ADDENDUM 2
TO THE CONTRACT PROVISIONS AND CONTRACT PLANS

TAYLOR BAY BEACH CLUB HOA
WASTEWATER TREATMENT FACILITY UPGRADE

G&O #22848.01

10/27/2026

DRAWING: **G-18** OF: **18**

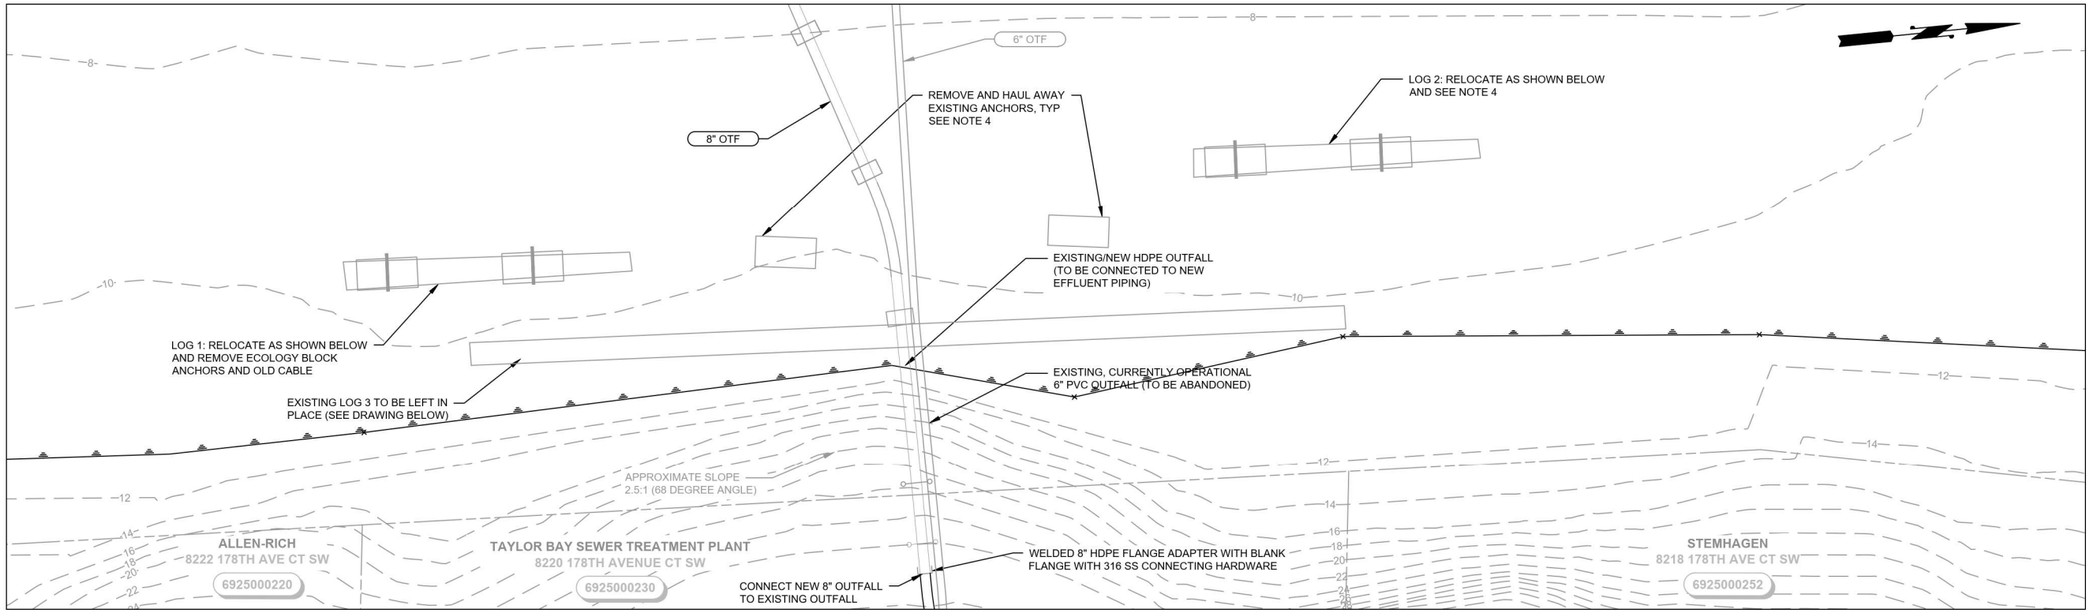
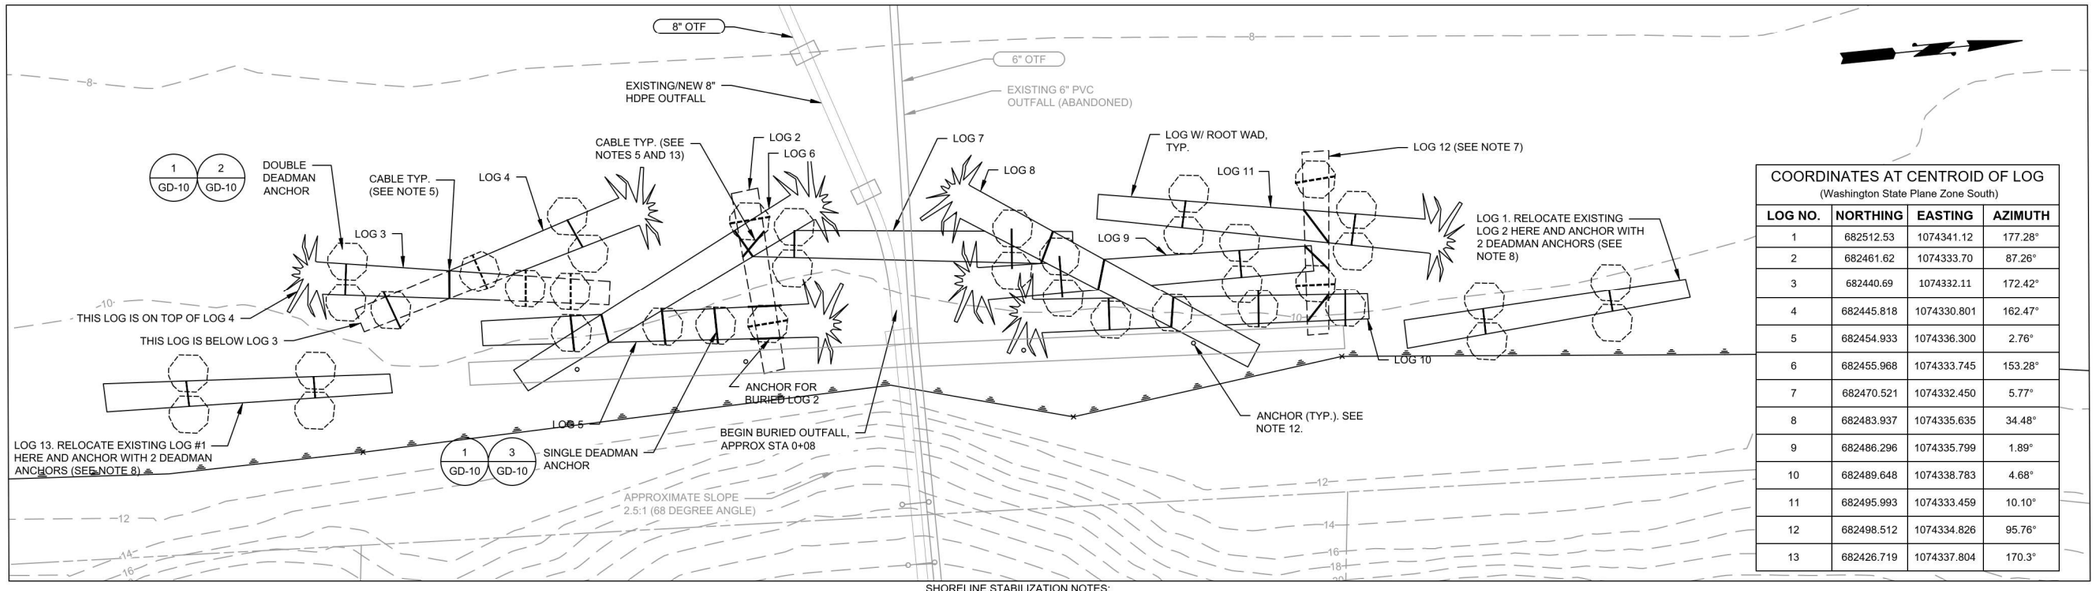
SHEET G-18, SHORELINE OUTFALL PROTECTION PLANS

ADD new Sheet G-18.

DRAWING: **GD-10** OF: **10**

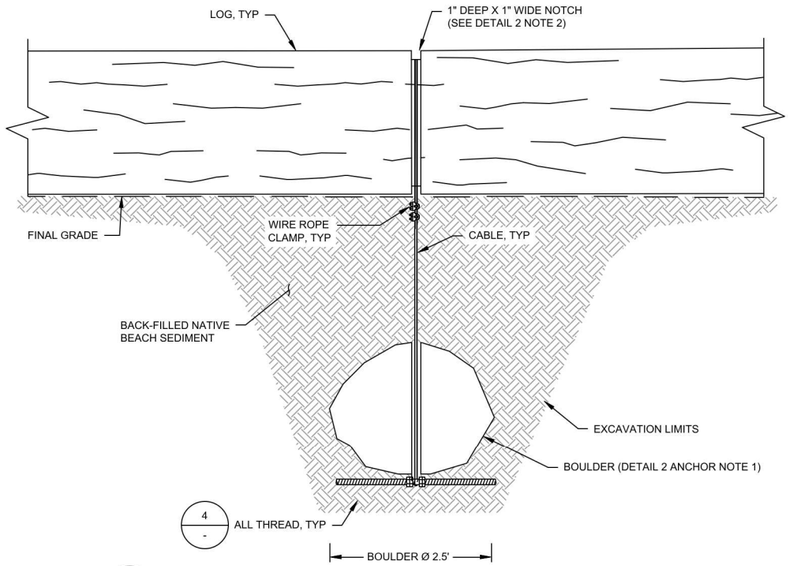
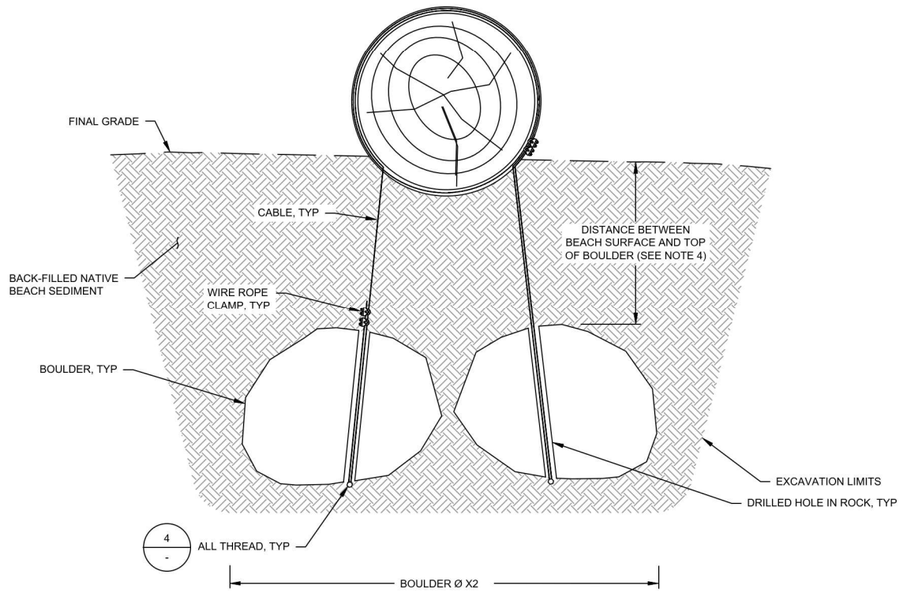
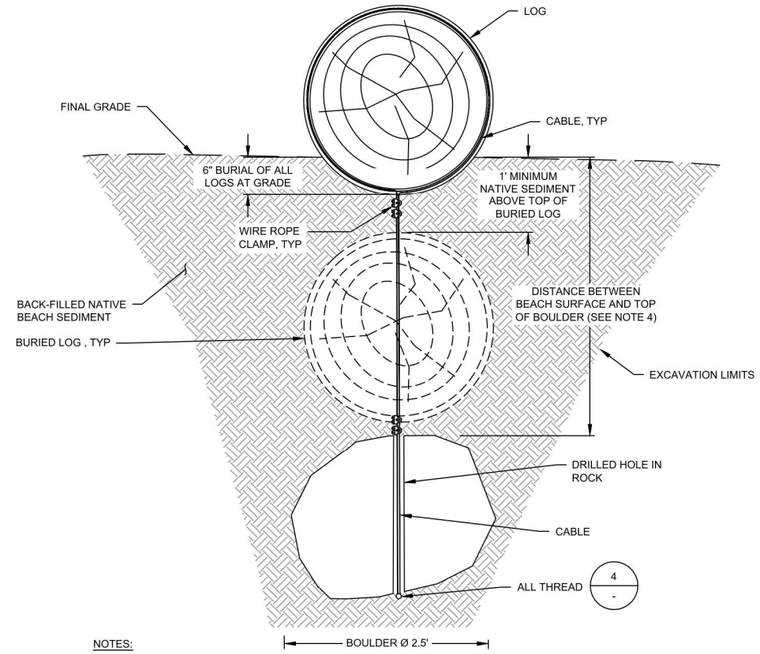
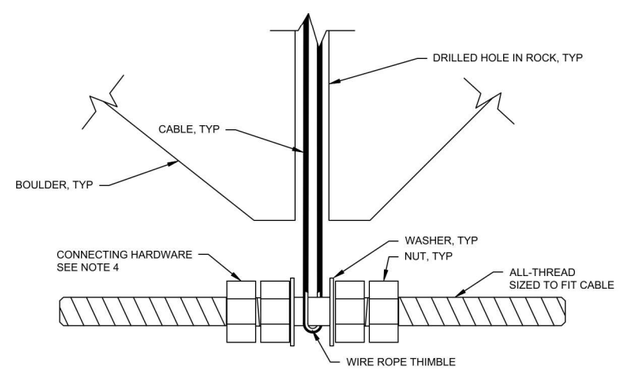
SHEET GD-10, SHORELINE OUTFALL PROTECTION DEVICES

ADD new Sheet GD-10.
